MEETING NOTICE AND AGENDA
TECHNICAL ADVISORY COMMITTEE
OF THE
SEASIDE BASIN WATER MASTER

DATE: Wednesday, May 14, 2014

MONTEREY PENINSULA WATER MANAGEMENT DISTRICT

**Revised and Updated Project-Specific Hydrogeologic Report
Peter and Grace Wang 26-Lot Subdivision
(PLN #010422)**

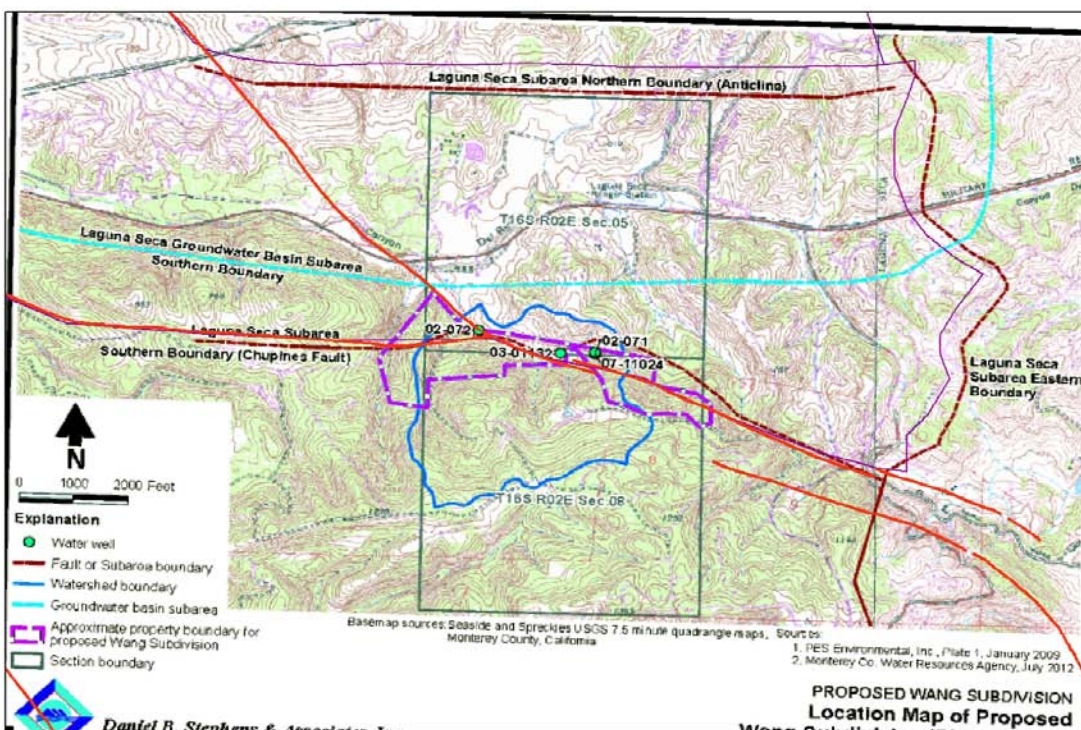
Figure 1, Location Map of Proposed Wang Subdivision. This map shows the location of the Wang property and wells, along with projections of the groundwater basin, subarea and Chupines Fault boundaries. We note that when this map is geo-rectified and compared with the GIS overlay coverage of the fault system and subarea boundaries from the Laguna Seca Phase III report (Yates and others, 2002), the boundaries do not precisely coincide. This is shown on **Attachment 1** below.

In particular, the location of the Chupines Fault is shown to wrap to the north of the main Wang wells on Figure 1 of the DBSA report, whereas the GIS overlay coverage shows fault traces plotting on the south side of these wells. The fault system coverage depicted in the Laguna Seca Phase III report was sourced from the USGS’s digital mapping of the Monterey and Seaside 7.5-minute quadrangles and Spreckels 7.5-minute quadrangle (Clark, Dupré and Rosenberg, 1997; and Clark, Brabb and Rosenberg, 2000; respectively). This uncertainty with respect to the Chupines Fault location on Figure 1 relative to the USGS map data, along with the paucity of water-level data, occurrence of Santa Margarita aquifer sediments adjacent to the Wang supply well screened intervals and lack of convincing evidence of an effective groundwater flow barrier between the Wang wells and the Laguna Seca Subarea as described above, underscores the need for a more comprehensive and defensible approach to resolving the issue of the hydrogeologic relationship between the Wang project wells and the Laguna Seca Subarea.
